Re: An Coimisiún Pleanála Ref. 324420-26 (formerly ABP-312434-22) – Proposed Dyrick Hill Wind Farm, Co. Waterford: Observations on the remitted application following the Order of the High Court (Record No. H.JR.2024.0001470)

An Bord Pleanála Ref: No. ABP-312434-22: Dyrick Hill Wind Farm

RE: Proposed Dyrick Hill Wind Farm, County Waterford (Ref. No. ABP-312434-22): A Strategic Infrastructure Windfarm Development consisting of 12 wind turbine generators, 110kv substation, connection to the national electricity grid and associated and ancillary works at Ballynaguilkee Upper, Broemountain, Corradoon, Dyrick, Lickoran, Lickoranmountain, Lisleagh, Lisleaghmountain, Lyrattin and Scartmountain, County Waterford.

Figure 1: Scart Mountain Wind Farm Site showing 2RD of Dyrick Hill Wind Farm site.

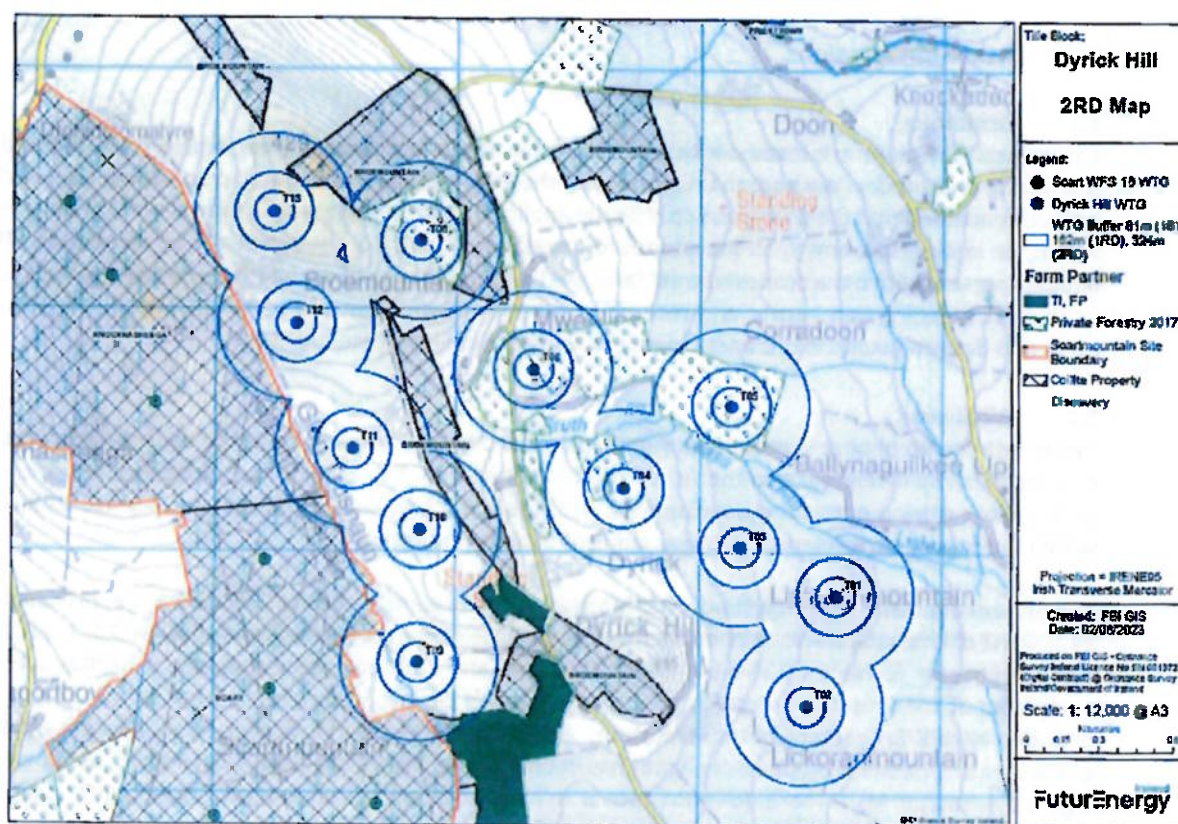
We would note that the intention of this set-back provision of the Ministerial guidelines is to address issues in relation to potential wind take and to protect the potential for wind farm development on adjoining property. As such, where turbines are located less than two rotor diameters from neighbouring properties, but there is no practical development potential on the neighbouring property, we would accept that a breach of this 2RD guidance limit could be acceptable. We therefore have no issue with the siting of the Proposed Wind Farm's T8 and T6 where there are minor 2RD exceedances in relation to Coillte owned lands, on the basis that the scale of these lands would be insufficient to enable development of turbines. However, the 5 No. turbines on the western boundary of the Proposed Wind Farm site (T09 – T13) are all exceeding the 2RD requirement and are adjoining lands which FEI currently enjoys exclusive land rights to, and that are the subject of our active Scart Mountain Wind Farm development project (Refer Figure 1 overleaf).

FEI's Scart Mountain Wind Farm project involves a significant financial investment from the shareholders of FuturEnergy Ireland. This investment has been underpinned by an assumption that any potential developments on neighboring lands would be required to follow the Ministerial Guidelines, given the significant wind energy development potential of the Scart Mountain Wind Farm Site. The FEI project has been in design development for several years (originally by Coillte and subsequently since its formation in 2021, by FEI) and was publicly launched in October 2022. The SID pre-application process has been initiated with An Bord Pleanála and a planning application is scheduled for late 2023.

The intent of the 2006 WEDGS is to preserve the development potential of neighbouring property for wind farm development. It is of significant concern that the Proposed Wind Farm fails to have regard to these Ministerial Guidelines.

An Bord Pleanála must have regard to the 2006 WEDGS, as required under Section 37G of the Planning and Development Act, and in circumstances where there is obvious wind energy development potential as is the case on our adjoining lands, Section 5.13 is clearly relevant to its consideration of the Proposed Wind Farm application. We see no objective, reasonable justification for not requiring strict compliance with the set-back prescribed in the 2006 WEDGS.

In practical terms, achieving compliance with the WEDG set-back distances requires the **removal or relocation of Turbines T09–T13 to respect the 2RD requirement**. FEI respectfully requests that the Commission make this the subject of a condition should it be minded to grant permission.
